Answer to reviewers

Reviewer 1

Reviewer 2

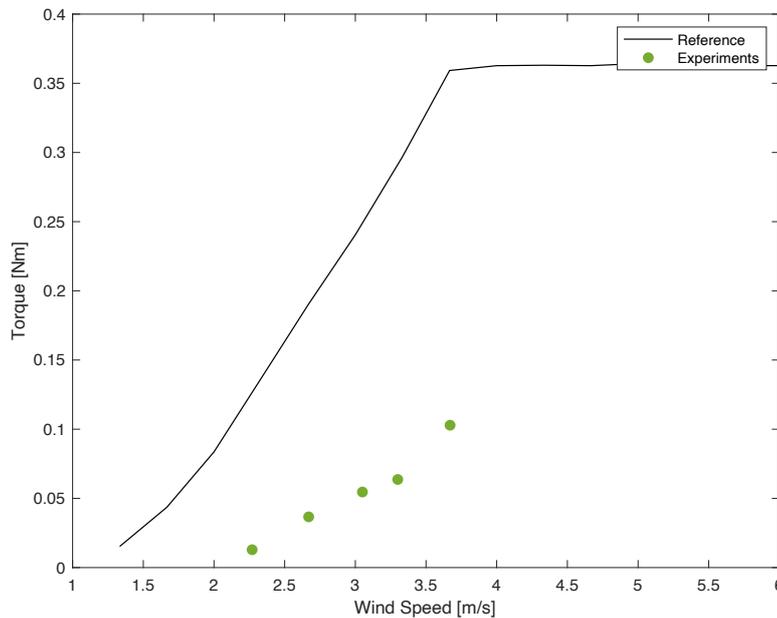
- Figure 2: in the caption it is said “The experimental points are averaged over two sets.”

Two sets of what? Please explain it in the text. You should briefly explain how the characterization was performed. I get that thrust is the main driver of the floating wind turbine response and it was the main objective of the scaling but also torque is important because the turbine is in the end a power generating machine. Can you also show the torque corresponding to the measured thrust reported in Fig. 2?

The characterisation of the rotor performance was performed in <https://doi.org/10.5194/wes-9-343-2024> where Figure 4 shows the thrust and power curve. Figure 2 of the current manuscript averages the values of the two sets of tests that are reported in Figure 4. Each set consisted of static tests (no motion) for 5 below-rated wind speeds and corresponding rotational speeds (TSR of 7.5). About 60 seconds were recorded for each test, and the forces in x-direction (thrust), moment in x-direction (torque) and rotor speed from encoder were averaged and power computed. In the current manuscript, we decided to show only the thrust as an indication of the rotor performance most relevant to the study. However, the paper showing both thrust and torque characterisation is cited in the caption of Figure 2 of the current manuscript. The torque curve is attached here. The torque values don't match the full-scale concept,

resulting in sensibly lower values. This was expected and also shown in the paper about the aerodynamic design of the turbine (by Fontanella et al.).

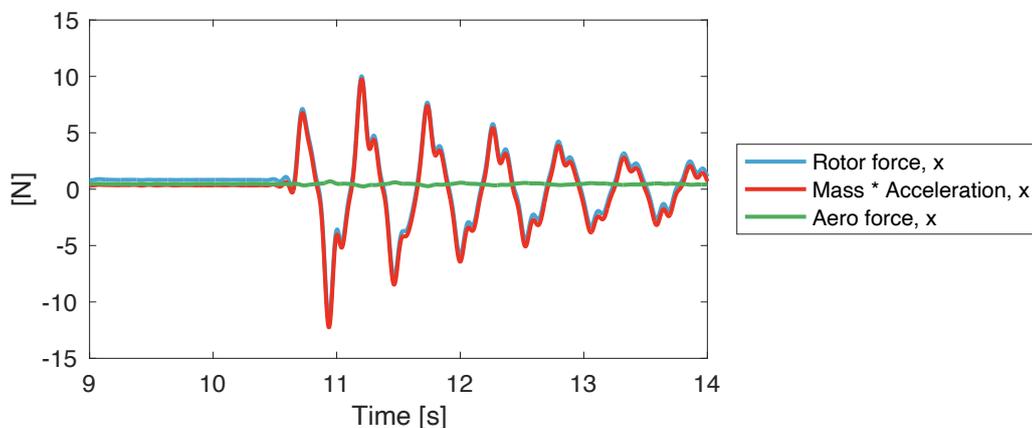
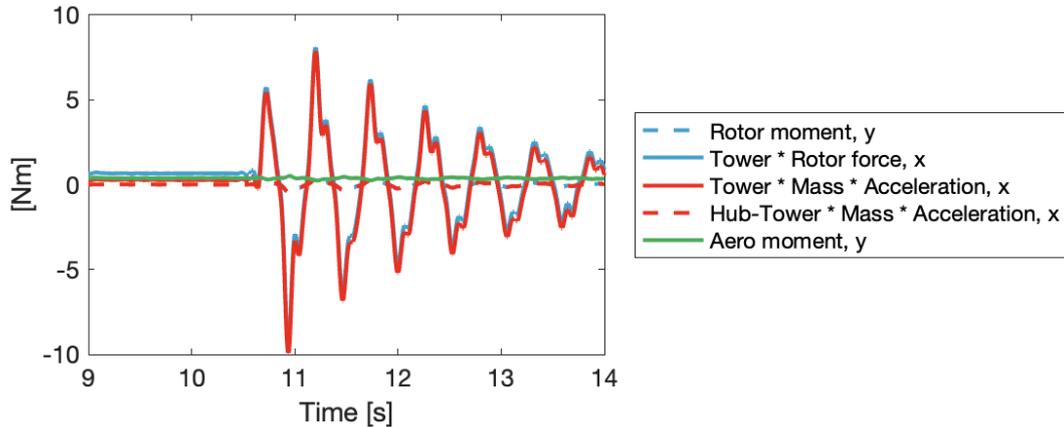
- L210-211: “the angular accelerations ... in the current setup”. Can you estimate the error on Aerodynamic loads you are committing by neglecting these terms? Or alternatively how much $T_{in}+T_{grav}$ change by neglecting the angular accelerations?

The error committed can be judged as negligible from the following analysis. The plots below show, for a decay case in no-wind conditions, the time history of relevant quantities to assess the force correction. They are shown for F_x and M_y as they are the key contributions. In the manuscript, these plots have been included and extended to all directions and more cases. The decay starts at about 10.5s from a displaced pitch position. The top plot shows the estimation of the aerodynamic force in x (surge) direction: blue solid line is the measured rotor force; the red solid line is the signal used to correct for inertial and gravitational contributions, i.e. the measured acceleration in x direction times the mass or the RNA; the green line is the aerodynamic force in x direction estimated by the model. As desired, the estimated aerodynamic force is approximately null (it is a no-wind condition where no aerodynamic force is expected on the rotor). The bottom plot shows the estimation of aerodynamic torque in y (pitch) direction about the s.w.l (tower bottom): the blue dashed line is the measured aerodynamic torque in y direction; the red solid line is the signal used to correct it, i.e. the measured acceleration in x direction times the mass or the RNA times the distance between the loadcell and the cog of the RNA; the blue solid line is the measured rotor force in x direction multiplied by the hub height (to calculate the torque at tower base); the red solid line is the signal used to correct it, i.e. the measured acceleration in x direction times the mass or the RNA times the hub height; the green line is the aerodynamic torque in y direction estimated by the model. Despite, in theory, the blue dashed contribution is not entirely corrected by the red dashed contribution, the two are almost equal. This shows that the missing correction term of RNA moment of inertia times the angular pitch acceleration is negligible, and overall, the estimated torque results in constant and null as desired. However, the uncorrected pitch moment could have a bigger effect in different motion cases, which is why the authors stated it as a drawback of the approach. Also, yaw direction remains totally uncorrected. Future developments will focus on how to estimate the angular accelerations relying on the acceleration sensors (as suggested by Reviewer 2).

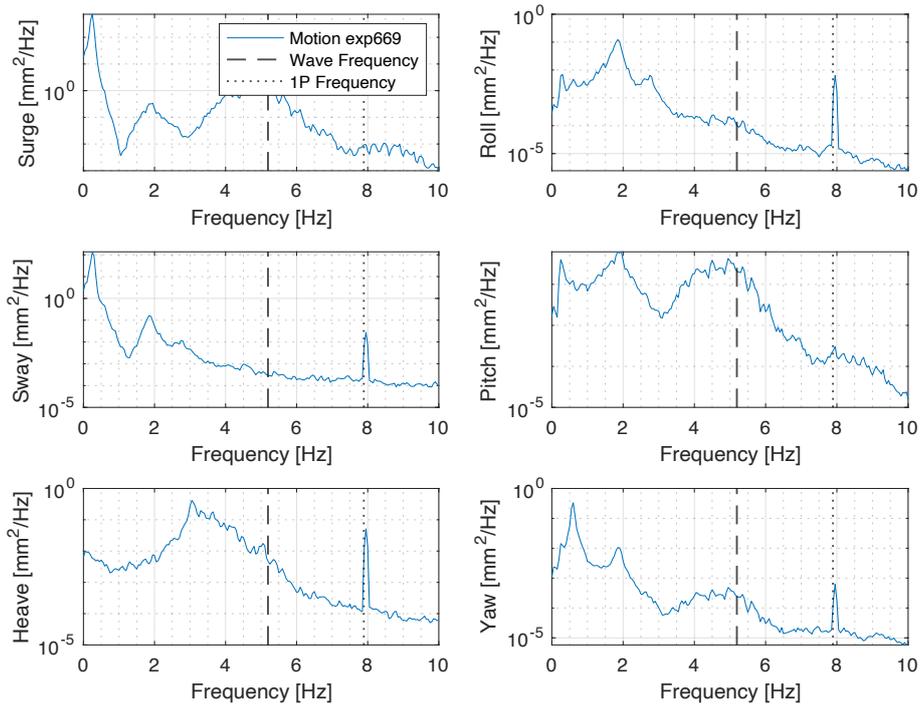
- Figure 9: Can you do some averaging when computing spectra (e.g., with Pwelch), otherwise it's difficult to identify the features of the spectra.

The figure has been changed with PSD computed with Welch's method:
